ADA Curb Ramp New Construction Inspection Form (Blended Transition)

NW MAIN ST

24953

NW NORTH AVE

ADA Curb Ramp Images

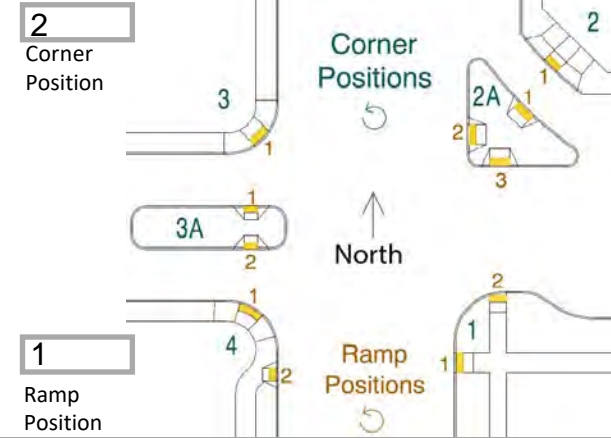
Large crack through gutter and curb
